Type II Staff Report and Decision
Notice to Parties of Record

Project Name: Cruanas Short Plat

Case Number: PLD2017-00060

Type II Staff Report and Decision

PROPOSED DEVELOPMENT PLAN & EXISTING CONDITIONS FOR:
CRUANAS SHORT PLAT

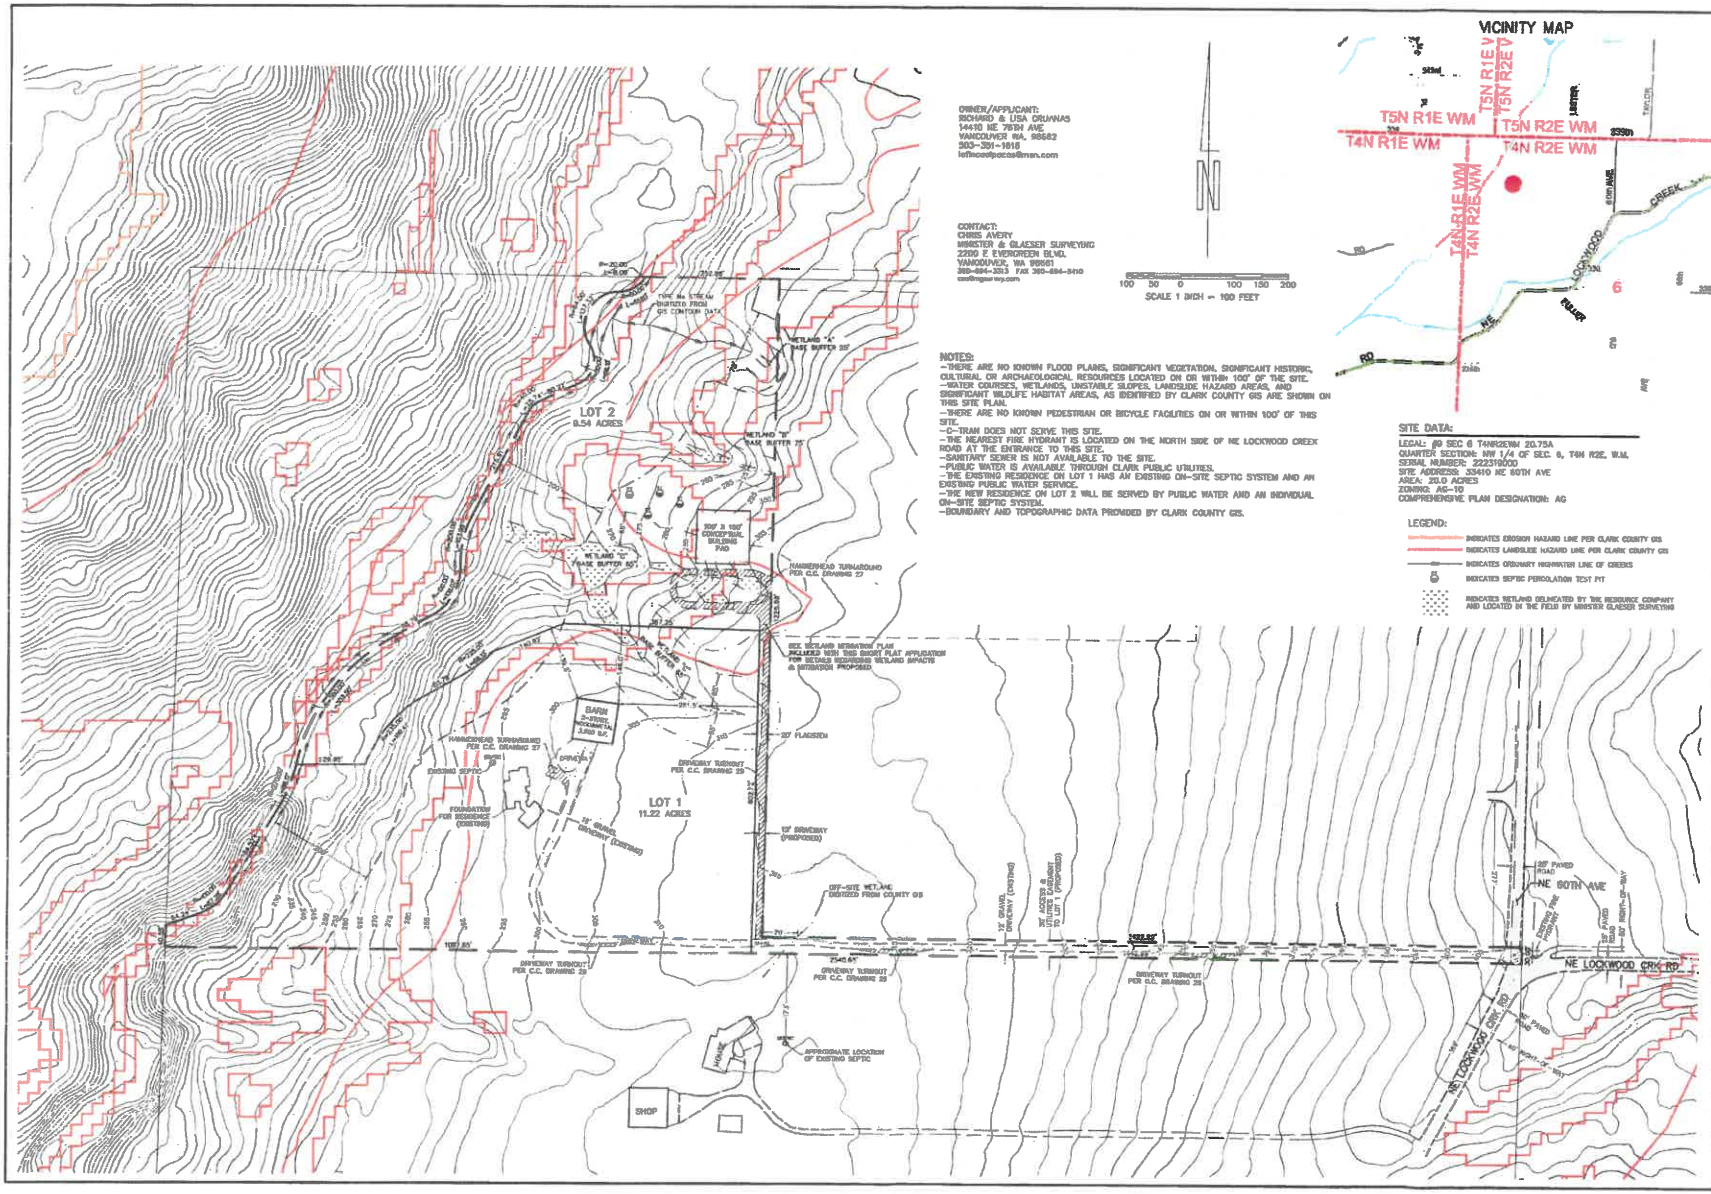
b. The preliminary plans provided propose a building envelope outside of the Low Intensity Use wetland buffer for Wetland A. The proposed driveway will cross Wetland A in two locations which would require a wetland permit; there is a recently placed culvert on the southern swale of Wetland A which would require a wetland permit and may be combined with the future driveway crossing.

b. The preliminary plans provided propose a building envelope outside of the Low Intensity Use wetland buffer for Wetland B. There do not appear to be any impacts to Wetlands B or C or their buffers.

The location of any wetlands, wetland buffers, and wetland mitigation areas shall be shown on the new plat and any future construction plans. As currently shown on the preliminary development plan, the proposed 100 foot by 100-foot building pad for Lot 2 is outside of the Low Intensity Use buffer for Wetland A and Wetland B which meets the Avoidance criteria in the Wetland Code. There is direct wetland and wetland buffer impacts associated with the proposed driveway to Wetland A which would require a wetland permit with applicable mitigation. The applicant has applied for the subject wetland permit (WET2017-00091) to address the impacts.

a. Development envelopes shall be shown on the final construction plan and final plat;

b. A note referencing the development envelopes shall be placed on the final construction plan and final plat.

d. The applicant shall place culverts of sufficient size to maintain water flow and a hydrologic connection between the eastern and western ends of Wetland C on either side of the proposed driveway. These culverts shall be indicated on the Final Construction Plans.
